# Architectural Review Board

Wednesday, November 20, 2024

## 112 S. Riverview Street 24-081MPR

#### *Rear (East) Elevation*

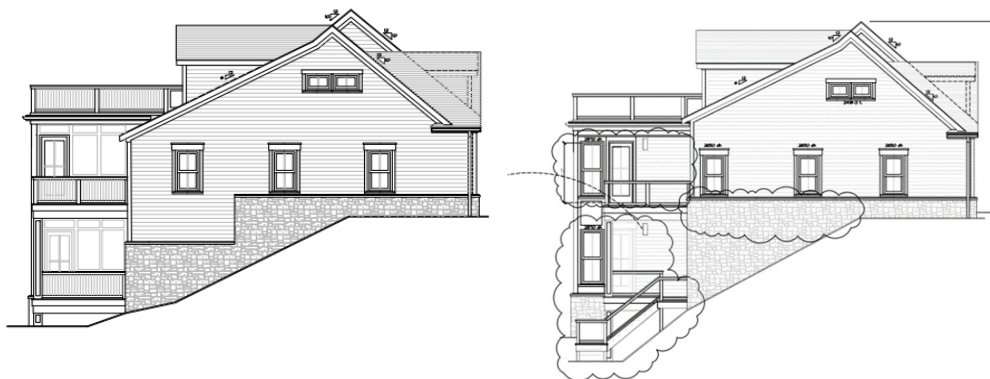
The applicant has reduced the width of the north and south decks to meet the building footprint requirement. The applicant also proposes window/door size changes at all levels of the rear elevation. The proposed changes are due to reduced deck sizes, to allow for access from the basement and to accommodate internal layout changes. The request is in line with the previously-approved application and does not impact the overall window arrangement. Staff is supportive of the proposed changes.

The applicant is now proposing a similar window opening arrangement on the south deck of both the floors, replacing the previously-approved door and window arrangement to better suit internal layout changes. At the middle bay, the applicant has made internal changes to the layout and proposes an inoperable window in the center (highlighted in blue). On the north deck, at the far right on the basement level, the proposal includes an additional door to allow access from the unfinished basement area. The basement layout was not presented in the previous approval. Staff is supportive of the proposed changes.

The applicant is now proposing a basement height of 12 feet instead of the previously-approved 11 feet, 1 inch. At the previous MPR approval, a Waiver was granted for the total rear height. The proposed basement height does not impact the overall height, as the applicant has used the existing grade change to accommodate the height. Staff is comfortable with this request, and a Waiver is not needed.

### *Right Side (South) Elevation*

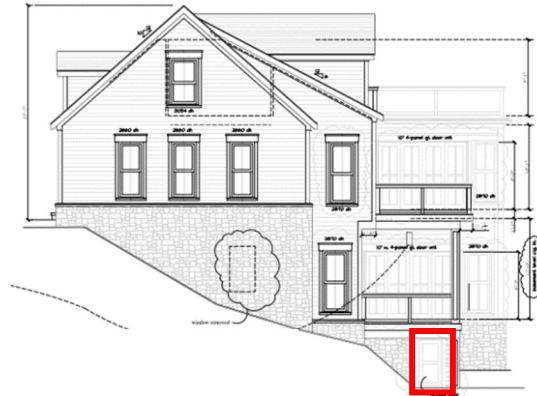
The applicant proposes to modify the sizes of the previously-approved deck to meet the building footprint requirement and condition. The applicant also proposes removing the lower level window as shown below due to construction limitations, and staff is supportive of the request. Instead of previously-approved doors and windows opening at the deck, the applicant now proposes four-panel bi-parting sliders on both the floors. Staff is comfortable with these requests. Staff supports the bi-parting sliders in this location due to limited public visibility and the close match with the amount of windows on the approved elevation.

The applicant also proposes to add an access door (highlighted in red above) to the unfinished basement area. Engineering has concerns with the door and the applicant is required to address the comments at Building Permit. This is included as a condition of approval.

- 1) The applicant shall provide basement access door details and utility plans detailing the scope of work to be reviewed, approved, and inspected by Engineering, at building permit.
